CHAPTER 3

Revisions to the Draft EIR

3.1 Introduction

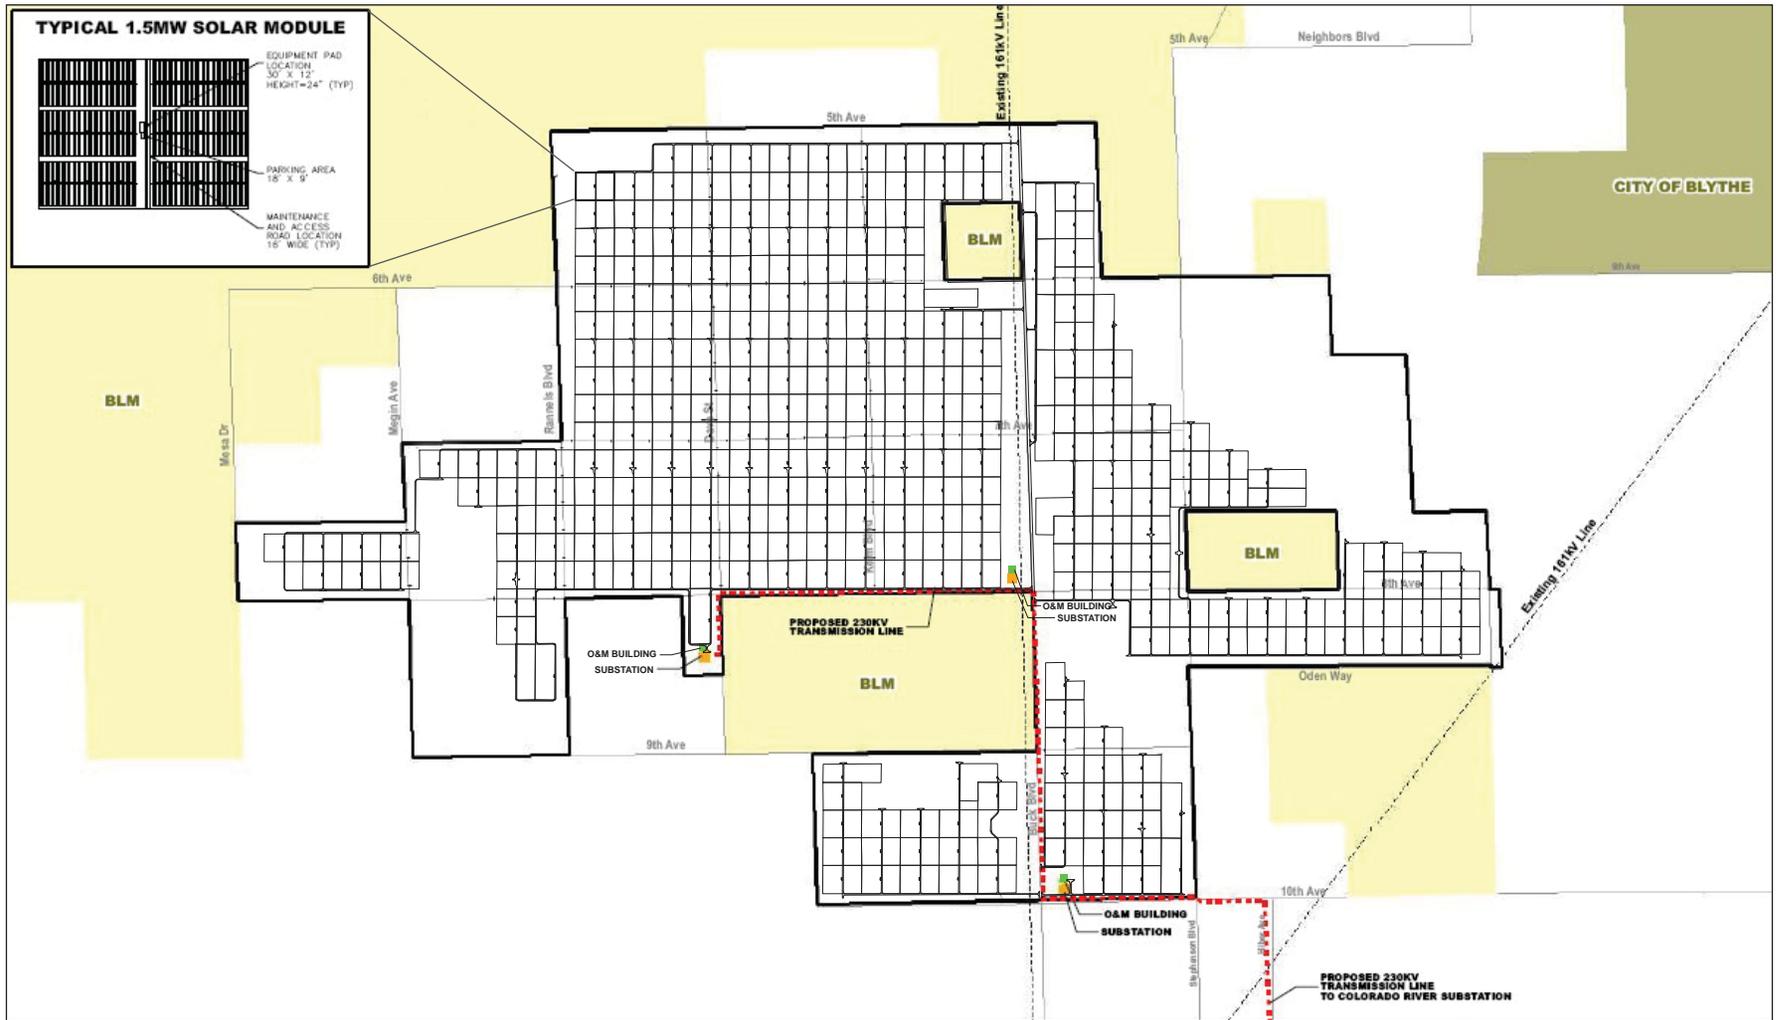
The Applicant provided revisions to the Chapter 2, Project Description, proposing the addition of one substation (with associated switchgear pads) and two O&M buildings. The revisions are shown in ~~strikeout~~ underline below. In addition, Figure 2-6 has been revised to show the locations of the proposed additional structures and to clarify that panel configurations may be revised during final design but will comply and remain consistent with land use requirements. As shown on Revised Figure 2-6, the additional substation and O&M buildings would be constructed within the boundary of the proposed the solar facility, which was wholly analyzed throughout the Draft EIR for potential disturbance. The new structures are proposed in locations where they would avoid existing archeological sites and sensitive biological resources. The closest newly proposed structure to a sensitive receptor for

purposes of noise or air quality would be 8,000 feet at the closest point. This is farther than the distances analyzed in the Draft EIR; therefore, the proposed location of the new structures within the solar facility site would result in no new or more significant impact than analyzed in the Draft EIR. Similarly, given the proposed locations relative to key observation points identified and analyzed in the Draft EIR, the proposed new structures would result in no new or more significant visual impact than analyzed in the Draft EIR. The applicant proposes no changes to the number of employees during construction or operations as a result of constructing or operating the additional structures. Construction of the additional structures would result in negligible additional vehicle trips during construction (i.e., associated with materials delivery) and, during operations (i.e., associated with regular septic system maintenance), and no or negligible delay of the construction schedule. The construction schedule analyzed in the Draft EIR was a conservative estimate that tended to overestimate rather than underestimate the number of days required for construction to assure that impacts associated with the reasonable maximum duration of construction would be analyzed and disclosed in the EIR. For these reasons, the analysis and conclusions in the Draft EIR would remain unchanged with or without the additional substation and two additional O&M buildings.

Note: Panel configurations may be revised during final design but will comply and remain consistent with land use requirements.

The ~~two~~ three on-site substations (each 300 feet long by 300 feet wide) would collect all the medium-voltage circuits and step up the voltage to 230 kV. The internal arrangement for the substations would include a 34.5 kV switchrack, a 230 kV switchrack, a 34.5 kV / 230 kV transformer yard, and a control building (see **Figure 2-11**).

~~One~~ Three O&M buildings (approximately 3,500 square feet, enclosed, and no more than 30 feet tall) would provide work space for maintenance staff and storage space for operational equipment and parts. The physical locations of the buildings are shown in *Figure 2-6 (Site Plan)*. The layout and elevations are illustrated in **Figures 2-13** and **2-14**. The buildings would be constructed with the finished floor a minimum of 24-inches above the highest adjacent ground. The buildings would include bathroom facilities serviced by a private septic system and would be designated occupancy Classification U. A covered outdoor temporary assembly and storage area (80,000 square feet, 25 feet tall) would be directly adjacent to each ~~the~~ O&M building.
